# Metropolitan Planning Commission

## Staff Reports

**March 26, 2009**

**Project No.** Zone Change 2009SP-002-001  
**Project Name** Primrose School SP  
**Council Districts** 31 - Toler  
**School Districts** 2 - Brannon  
**Requested by** Stantec Consulting Services Inc., applicant, for Chi Wai Lee, owner  
**Deferral** *Deferred from the March 12, 2009, Planning Commission meeting*  
**Staff Reviewer** Bernards  
**Staff Recommendation** *Approve with conditions*

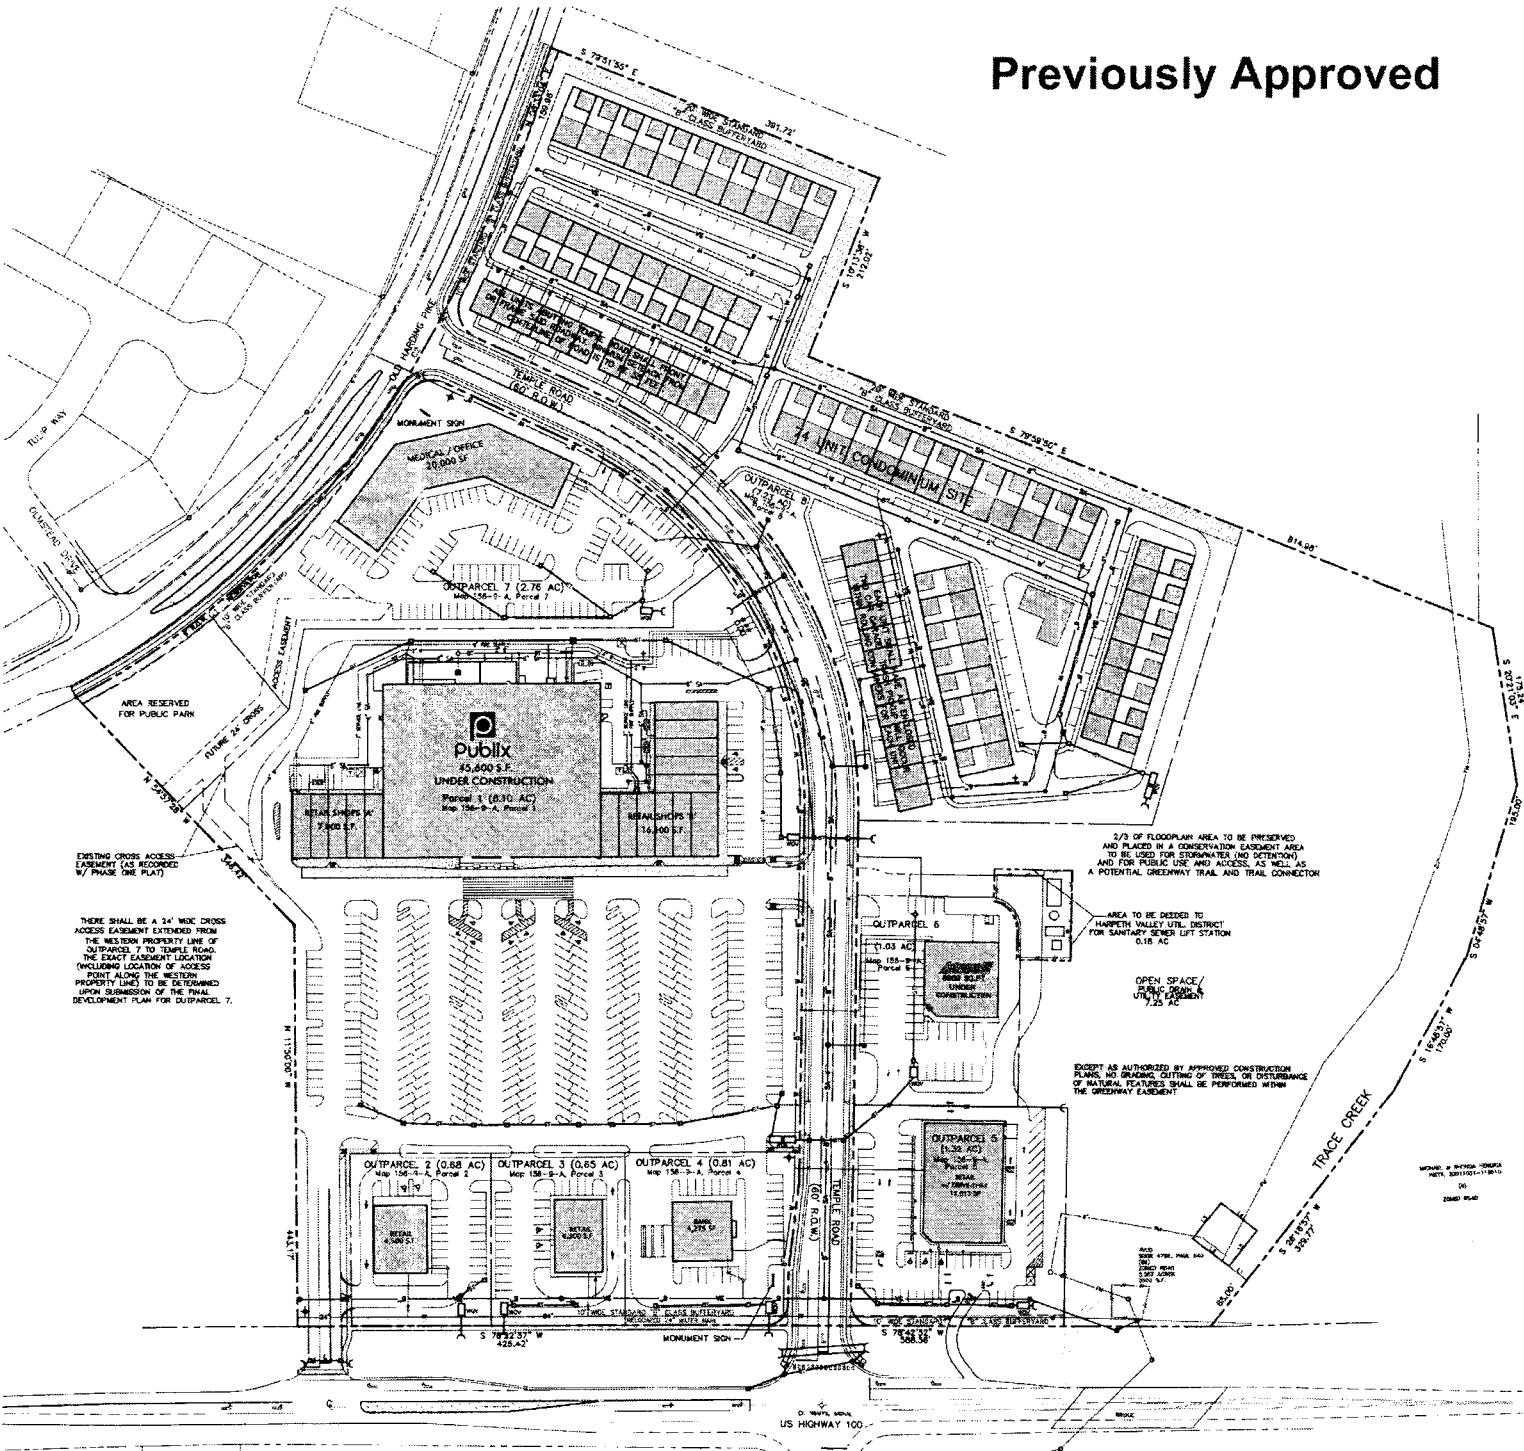
1. A copy of the Tennessee Construction General Permit NOC letter will be required to complete technical review.
2. Include North Arrows on plans.
3. Construction site entrances/exits are to be a minimum of 100-feet in length.

4. Include a note on the Initial Erosion Control Plan requiring the contractor to provide an area for truck wash and equipment fueling in accordance with Metro CP-10 and CP-13, respectively. Contractor to coordinate exact location with NPDES department during preconstruction meeting.

5. Several MWS BMP reference numbers are missing.
6. Provide the Sediment Trap sizing calculations and add the trap stone outlet detail drawings to the plans. As the Harpeth River is a designated 303(d) stream, the erosion control BMPs, specifically the Sediment Trap, must be designed to contain the runoff from the 5-year storm event.

- size, material, invert elevation(s), actual flow and capacity of the structures.
8. On the plans, provide a Drainage Table showing all proposed storm system structures including inlets, outlets, junction boxes, and ditches. List pipe size, length, invert elevations, slope, and ground elevation. Indicate the building roof drainage discharge locations on the plans. No curb cuts were called out on the grading plan, delete the curb cut detail.

9. Provide the hydraulic grade line at each structure through to the outlet. Provide the inlets' capacities.
  10. Provide pipe flow capacity and full pipe velocities using Mannings equation.

11. MWS requires a certification letter from Contech Stormwater Solutions, Inc. on the Stormfilter design. Contech is aware of the certification requirement. The letter is to state the information provided to Contech: Total Drainage Area, Percent Impervious, Average runoff coefficient, Water Quality Volume, and Total Detention Volume. Include the selected design drawing on the plan detail sheets.

12. Add a note to the plans that all erosion control measures are to be removed prior to as-built approvals.
  13. Due to the design life of the proposed building, advise specifying RCP.

# Proposed Plan

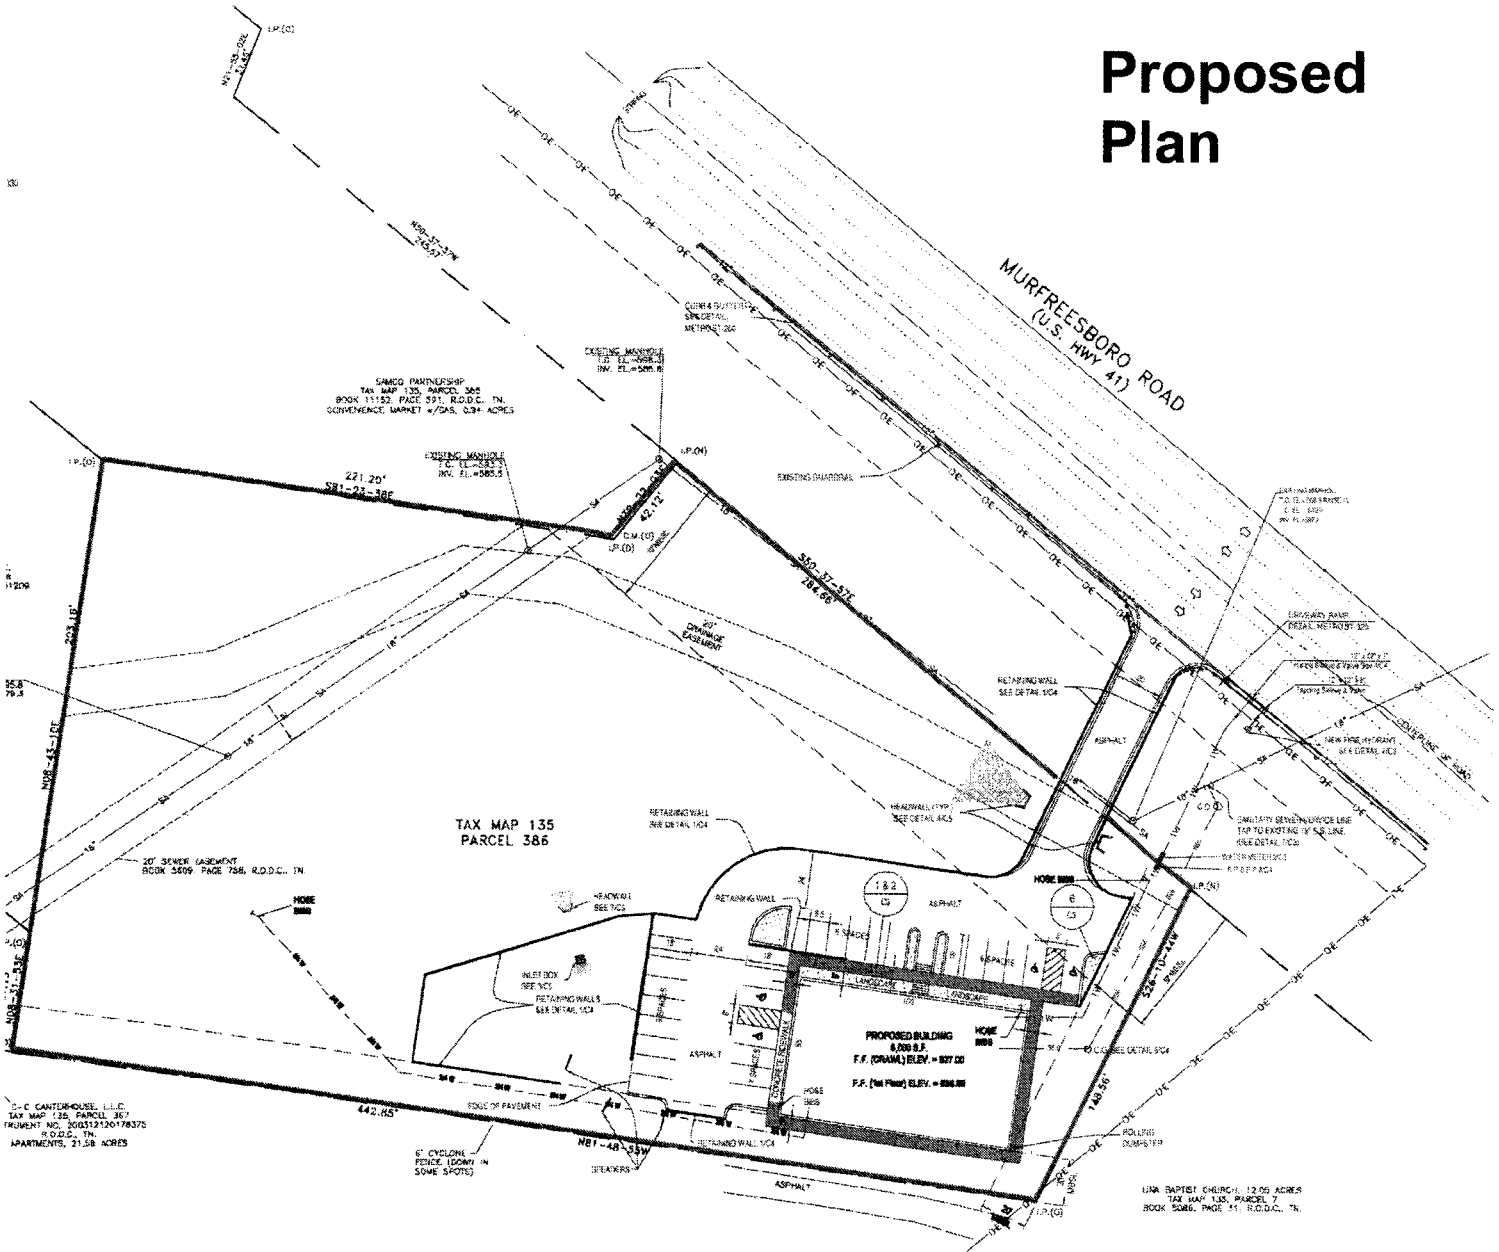
The property is within the Urban Services District and sidewalks are required along Murfreesboro Pike. The plan does not provide any sidewalks and the applicant has asked that sidewalks not be required. The drainage ditch that bisects the property runs somewhat parallel with Murfreesboro Pike. The base of the ditch is deep and the ground drops away from Murfreesboro Pike towards the center line of the ditch. Construction of the sidewalk would require that the area immediately adjacent to Murfreesboro Pike be filled. Due to cost of the sidewalk construction the applicant has asked that the sidewalk not be required.

2. Remove traffic diverters islands from driveway ramp. Ramp is to be constructed per the Department of Public Works standards and specifications.
3. Trash enclosure /dumpster location does not appear accessible for a SU-30 design service vehicle. The solid waste collection and disposal plan is to be reviewed and approved by the Department of Public Works Waste Division.
4. Align driveway with opposing drive.
5. Provide adequate sight distance at access drive.

1. Provide an area site sketch of redesigned development drainage sub-areas.
2. Location of proposed curb cut does not provide a grass channel minimum of 50 feet for water quality. A solution is to move it to the east nearer the proposed building. Provide rip-rap outlet protection angled to flow into grass channel. Due to the amount of area of the parking lot and driveway entrance, advise placing inlets and pipe system to discharge into the grass channel.

3. Provide berm at the Grass Channel entrance into the Detention Pond area to ensure all flow runs into the pond area.
4. MWS easements will be required for the grass channel which is placed in the building setback. Minimum easement width is 10 feet greater than the top width of the channel with a minimum of 5 feet on one side. Provide a completed Dedication of Easement for the MWS easements.

5. Add a note to the plans that all erosion control measures are to be removed prior to as-built approvals.
6. Replace "Metro Nashville Public Works" in Note No. 5 in the Stormwater Pollution Prevention notes on C2 to "Metro Water Services".

- slope and length as shown on the plans. Including it may decrease the pond volume significantly.
- b. The weir should be set at the Water Quality Volume Elevation. The weir is shown as 9-inches on the plans while it is 0.58-inches or 7-inches in the printouts.

- c. The 3.50-inch orifice can be removed.
8. Add an emergency overflow weir at the Detention Pond set at the 100-year event elevation.
  9. Specify the waterproofing for the pond wall in the Block Retaining Wall Detail Drawing on Plan Sheet C4.

10. Add erosion control, such as rip-rap to the Curb Cub Detail Drawing on Plan Sheet C4.
  11. Add reference to MWS BMP PESC-07 in the Drain Pipe Apron Detail Drawing on Plan Sheet C5.

12. Add reference to MWS BMP PESC-08 in the Grass Channel Detail Drawing on Plan Sheet C5.
  13. Add MWS BMP PESC-02 Geotextile Detail Drawing to Plan Sheet C5.

14. On the Inlet Box (Outlet Structure) Detail Drawing:
    - a. Show the Water Quality elevation and the 100-year elevation at a minimum.
    - b. The 15-inch outlet pipe invert elevation is 602.0, Plan Sheet C2 indicates 602.50.

- c. Grate cover for the Inlet Box is missing from the Detail Drawing on Plan Sheet C5.
    - d. Advise using one low flow orifice.
    - e. The 3.75-inch pipe of unknown material can be removed.

- f. Add a note on the Inlet Box Detail Drawing on Plan Sheet C5 that the contractor shall remove the stone filter upon project completion.
  15. Add a note on the plans that all rock or rip-rap to be placed over Filter Fabric.

1. A sidewalk shall be shown along Murfreesboro Pike, or the applicant shall make a contribution to the pedestrian network in lieu of construction of the sidewalk. Prior to the issuance of building permits a revised plan shall be submitted showing sidewalks, as required by the Zoning Code, or the Codes Department shall forward confirmation that the in lieu payment has been accepted.

2. An internal sidewalk shall be provided along the entrance drive connecting the internal sidewalk to Murfreesboro Pike. If a contribution is made to the pedestrian network in lieu of the construction of the sidewalk along Murfreesboro Pike, or the BZA grants a variance from the sidewalk requirement then the internal sidewalk shall not be required. Prior to the issuance of building permits a revised plan shall be submitted showing the internal sidewalk, or the Codes Department shall forward either the confirmation that the in lieu payment has been accepted for the required sidewalk along Murfreesboro Pike, or that the BZA has approved a variance from the sidewalk requirement.

3. Buffer yards shall be shown along the southern and eastern property line as required by zoning. Prior to the issuance of building permits a revised plan shall be submitted showing the buffer yards as required by the Zoning Code.
